**NM1 - 19**

# **INSPECTIONS & DATA**

GANDY MARLEY INC.

ATTACHMENT 1  
INSPECTION REPORT  
PERMIT NM-01-0020  
GANDY MARLEY, INC.

FIGURE 3  
 Site Diagram

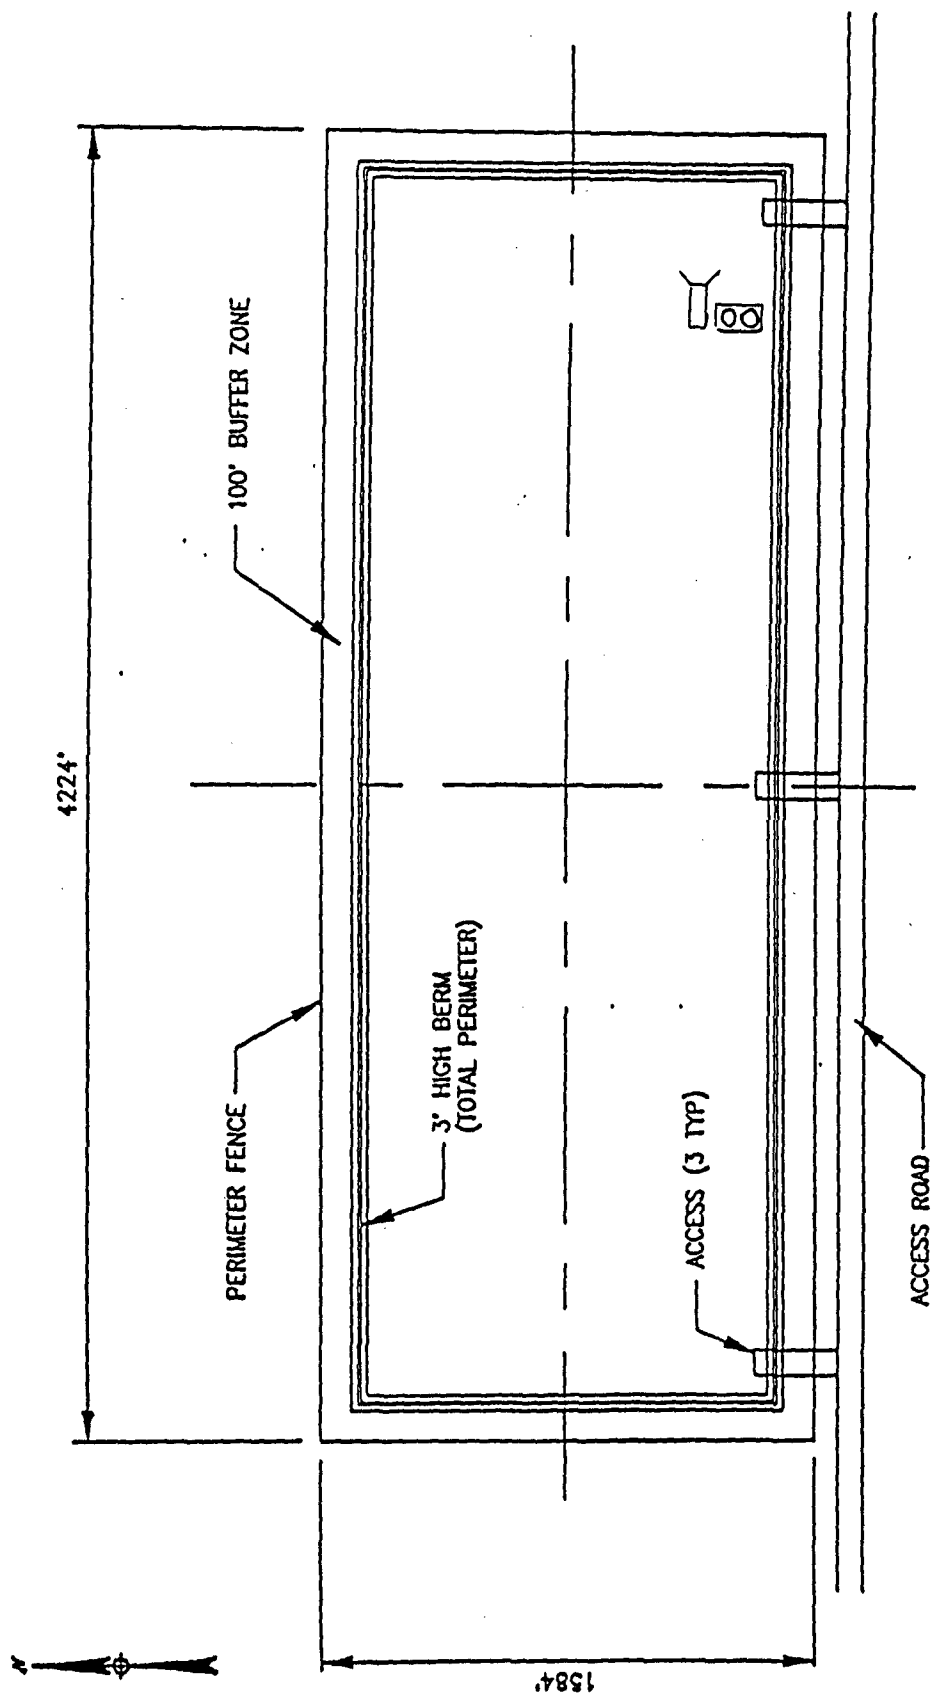
**Some of this is already on file with the OCD. Attached is a copy of the facility map that we have in the file please submit an updated facility map that reflects any changes that have been made. Please include a map that shows all of the current cells in use and or under construction, the location of the skim and receiving tanks, solidification trough, and the office.**

**PHOTO NO. 1      DATE: 04/4/97**

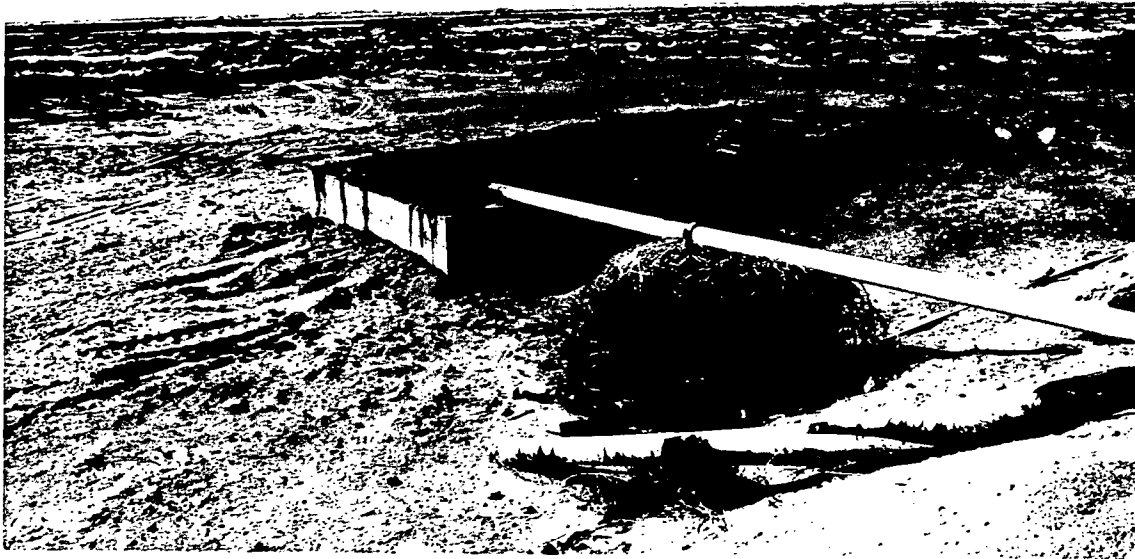
**solidification. Liquids and sludges to be landfarmed are first solidified within a concrete trough underlain with a 20 mil HDPE liner (see pictures 1, 3 and 4)**

**Above ground tanks are bermed to contain a sufficient volume and are on an impermeable 20 mil HDPE liner (see picture 2).**

**Tanks are not labeled as to their contents and hazard (see picture 2).**

**PHOTO NO. 3**

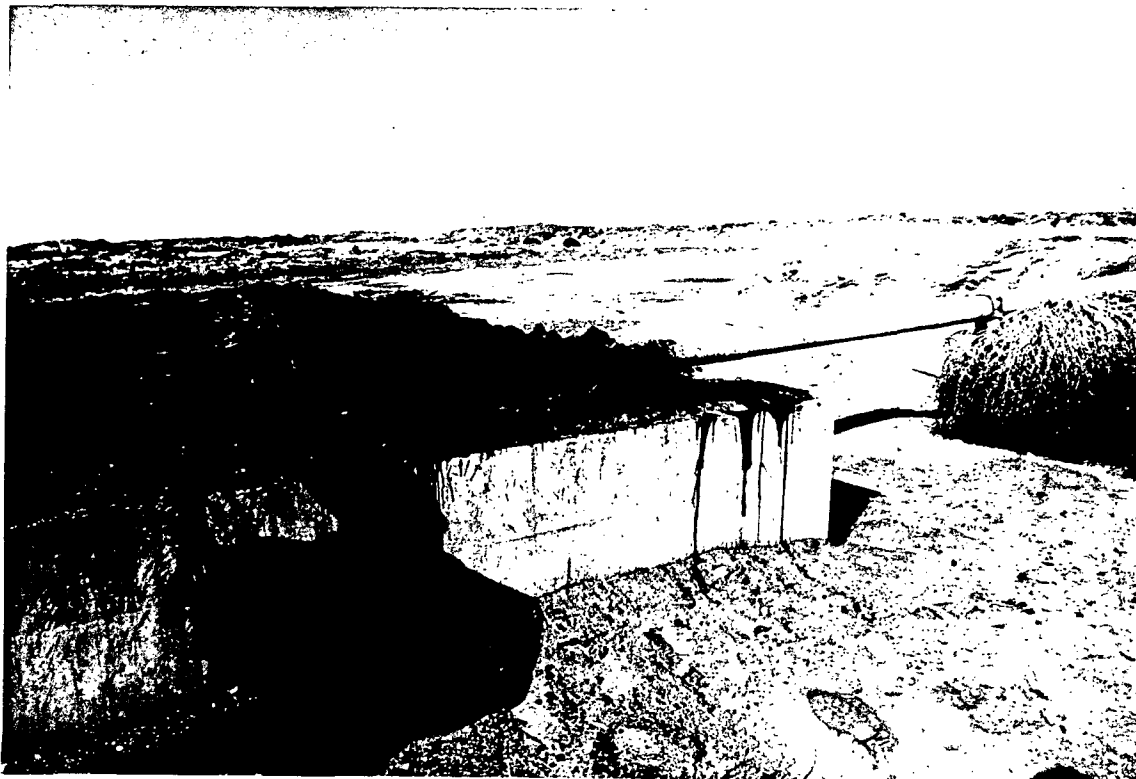
**At the time of inspection the tank berms and solidification trough were in good condition (see pictures 1, 2, 3 and 4). These systems should be checked on a regular basis.**
